Access Compliance Report Public Rights-of-Way (Curb Ramps)

Main Street: SUERTE_ST Cross Street: MEDANO_ST Location: NW

ADA ID: RPRK211124135145 Ramp Type: Type 1 - Perpendicular Diagonal Initial Pass/Fail: Fail Overall Compliance: No Severity Score: 2

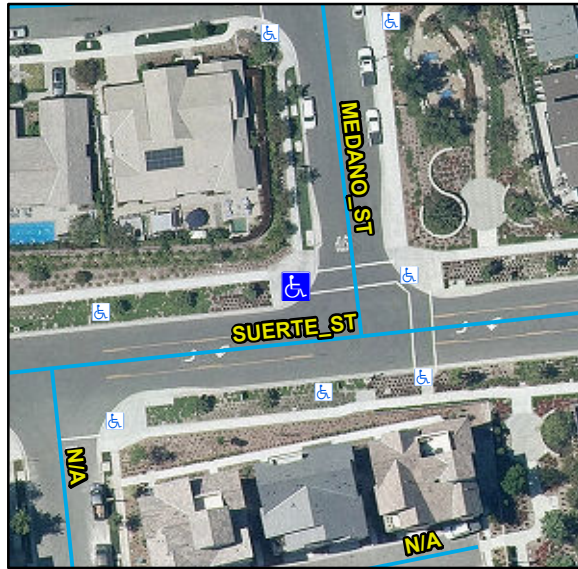
R304.2.2, R304.5.3, STD 1115

Compliance	Description	Data	Compliance	Description	Data
N/A	Ramp Length (in)	103	N/A	Flare Type LT	
Yes	Ramp Width (in)	48			N/A
Yes	Ramp Run Slope (%)	3.7	N/A	Flare Slope LT (%)	N/A
No	Ramp Cross Slope (%)	3	N/A	Flare Traversable LT	N/A
N/A	Landing Present	N/A	N/A	Flare Type RT	
N/A	Landing Length (in)	N/A			N/A
N/A	Landing Width (in)	N/A	N/A	Flare Slope RT (%)	N/A
N/A	Landing Run Slope (%)	N/A	N/A	Flare Traversable RT	N/A
N/A	Landing Cross Slope (%)	N/A	N/A	DWS Provided	N/A
N/A	Landing Movement Obstructed?	N/A	N/A	DWS Contrast	N/A
	Landing Movement Type	N/A	N/A	DWS Length (in)	N/A
N/A	Landing Shared	N/A	N/A	DWS Full Width	N/A
N/A	Clear Space	Yes	N/A	DWS Offset Left (in)	N/A
N/A	Clear Space To Crosswalk (in)	N/A	N/A	DWS Offset Right (in)	N/A
N/A	Marked Crosswalk 1	No	N/A	Marked Crosswalk 2	Yes
	Crossing 1 Direction	S		Crossing 2 Direction	E
	Marked Crosswalk 1 Width (in)	N/A		Marked Crosswalk 2 Width (in)	144

N/A	Ramp Inside Crosswalk 1	N/A	Yes	Ramp Inside Crosswalk 2	Yes
	Crossing 1 Slope (%)	2.5		Crossing 2 Slope (%)	3.4
	Crossing 1 Cross Slope (%)	2.5		Crossing 2 Cross Slope (%)	2.5
N/A	Gutter Ponding	N/A	No	Curb Slope	12.9
Yes	Gutter Lip Height (in)	0		Road Run Slope (%)	3.2
N/A	Gutter Run Slope (%)	N/A		Road Cross Slope (%)	1.8
N/A	Gutter Cross Slope (%)	N/A			
Yes	Overall Surface Condition: Acceptable		Yes	Perp Joint Present	Yes
	Cross Gutter Present?	No		Spandrel Present?	No
	Replace Cross Gutter?	N/A		Replace Spandrel?	N/A

Remove & Replace Curb Ramp With Two New Directional Ramps or Equivalent.
